UNITED STATES PATENT AND TRADEMARK OFFICE

APPLICATION NO.	FILING DATE	FIRST NAMED INVENTOR	ATTORNEY DOCKET NO.	CONFIRMATION NO.
10/743,362	12/22/2003	David M. Scoville	00655P1218US	7971

Office Action Summary	Application No. 10/743,362	Applicant(s) SCOVILLE ET AL.	
	Examiner Tho v Duong	Art Unit 3743

DETAILED ACTION

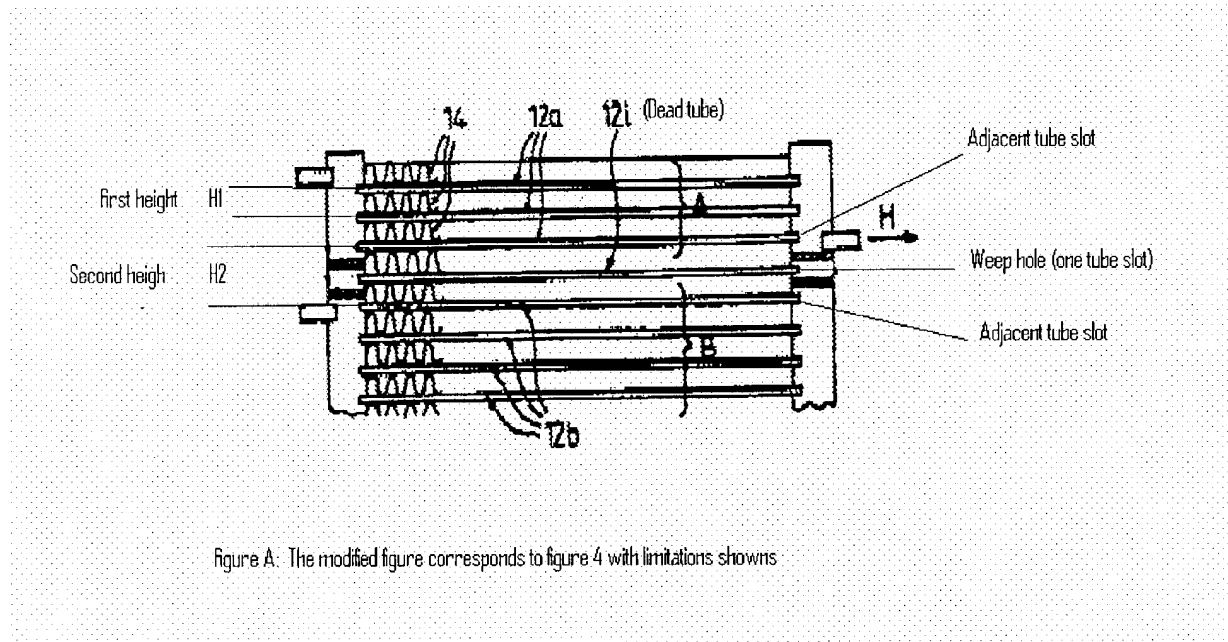
Claims 1-8 are rejected under 35 U.S.C. 102(b) as being anticipated by Marsais (US 6,394,176). Marsais discloses (figure 4) a multi-fluid heat exchanger having separate flow paths for at least two fluid streams, comprising first and second, elongated, spaced, parallel tubular headers (16,18) having opposite ends; spaced elongated tube slots in each of the headers with the tube slots in one header facing and aligned with the tube slots in the other header; a plurality of flattened tubes (12a,12b) extending between the headers and having ends receiving in aligned ones of the tube slots; one tube slot, which is inserted by a dead tube (12i), in each of header being unoccupied by any one of the flattened tubes (12a,12b); the one tube slots in each header being aligned with each other and located at a predetermined location between the ends of the headers and between two groups of the flattened tubes (12a,12b); a pair of baffles (20) in each header, one on one side of the one tube slot and between the adjacent tube slot on the one side and the other baffle on the opposite side of the one tube slot and between the adjacent tube slot on the opposite side; there are two group of tubes (A,B) and serpentine fins (14) extending between and in heat transfer relation with at least the adjacent tubes in each of the two groups; an additional fin (14) in heat transfer relation with an end tube in each of the two groups (A,B), one of end tubes being in the adjacent tube slots on the one side and the other of the end tubes being in the adjacent tube slots on the opposite side. Marsais further discloses that the tube slots associated with the two groups (A,B) are generally uniformly spaced in each of the headers. Marsais further discloses (figure 4 and figure A as follows) that the first serpentine fins (14), which disposed within the two group tubes (A,B), has a first height and extends between and bonded to the adjacent tubes in each of the two group tubes (A,B); and a second additional

serpentine fins, which disposed outside of two group tubes (A,B), has a second height being equal to about twice the first fin height plus the minor dimension of the tube.
